REACTOR TRIP SYSTEM INSTRUMENTATION TRIP SETPOINTS

TSC 92-01
PAGE 5

SEABROOK - UNIT 1
9203300253 920320
PDR ADDCK 05000443
PDR

IV. Safety Evaluation of License Amendment Request 92-01 Proposed Changes

TABLE 2.2-1

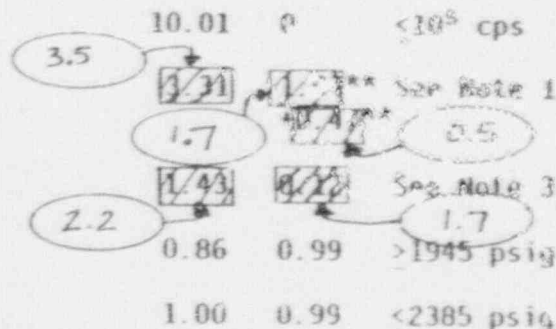
FUNCTIONAL UNIT	TOTAL ALLOWANCE (TA)	Z	SENSOR ERROR (S)	TRIP SETPOINT	ALLOWABLE VALUE
1. Manual Reactor Trip	N.A.	N.A.	N.A.	N.A.	N.A.
2. Power Range, Neutron Flux

a. High Setpoint	7.5	4.56	0	<109% of RTP*	<111.1% of RTP*
b. Low Setpoint	9.3	4.56	0	<25% of RTP*	<27.1% of RTP*
3. Power Range, Neutron Flux, High Positive Rate	1.6	0.5	0	<5% of RTP* with a time constant >2 seconds	<6.3% of RTP* with a time constant >2 seconds

4. Power Range, Neutron Flux, High Negative Rate	1.6	0.5	0	<5% of RTP* with a time constant >2 seconds	<6.3% of RTP* with a time constant >2 seconds
5. Intermediate Range, Neutron Flux	17.0	8.41	0	<25% of RTP*	<31.1% of RTP*

6. Source Range, Neutron Flux	17.0	10.01	0	<10 ⁵ cps	<1.6 x 10 ⁵ cps
7. Overtemperature ΔT	6.5	3.5	1.7	See Note 1	See Note 2
8. Overpower ΔT	4.9	4.8	1.7	See Note 3	See Note 4

9. Pressurizer Pressure - Low	3.12	0.86	0.99	>1945 psig	>1,931 psig
10. Pressurizer Pressure - High	3.12	1.00	0.99	<2385 psig	<2,398 psig

**The sensor error for T_{avg} is 1.7 and the sensor error for Pressurizer Pressure is 0.5. "As measured" sensor errors may be used in lieu of either or both of these values, which then must be summed to determine the overtemperature ΔT total channel value for S.
